GOVERNMENT OF THE DISTRICT OF COLUMBIA
DEPARTMENT OF TRANSPORTATION

MEMORANDUM

SUBJECT: BZA Case No.18688 - 1348-1356 Florida Avenue, NE

Figure 1 On-Street Block Face Map (Gorove/Slade)

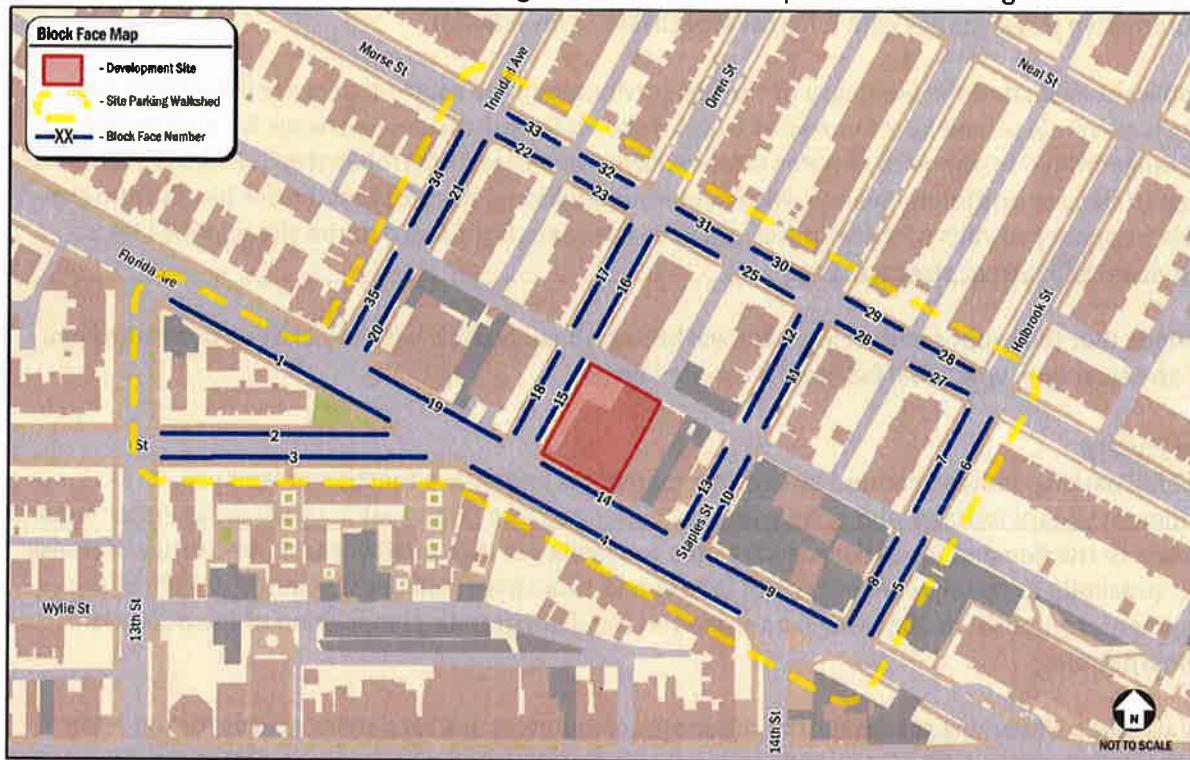
The Applicant's analysis of weekday on-street parking included the following blocks in the study area as seen in Figure 1: Block Face Map. Based on the Applicant's report, there are a total of 125 parking spaces in the study area during the weekday period, of which 47 are subject to Residential Permit

Figure 2 Summary of Parking Type (Source: Gorove/Slade)

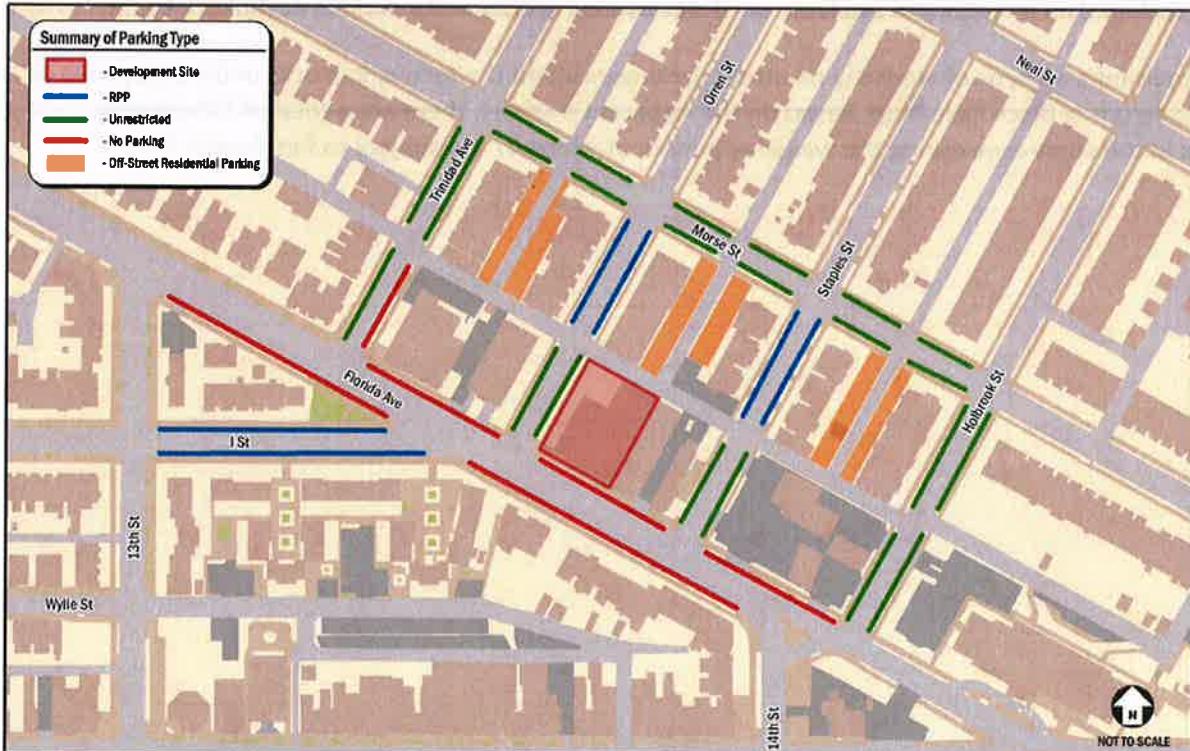
Parking (RPP) restrictions and the remaining 78 are unrestricted spaces as seen in Figure 2.
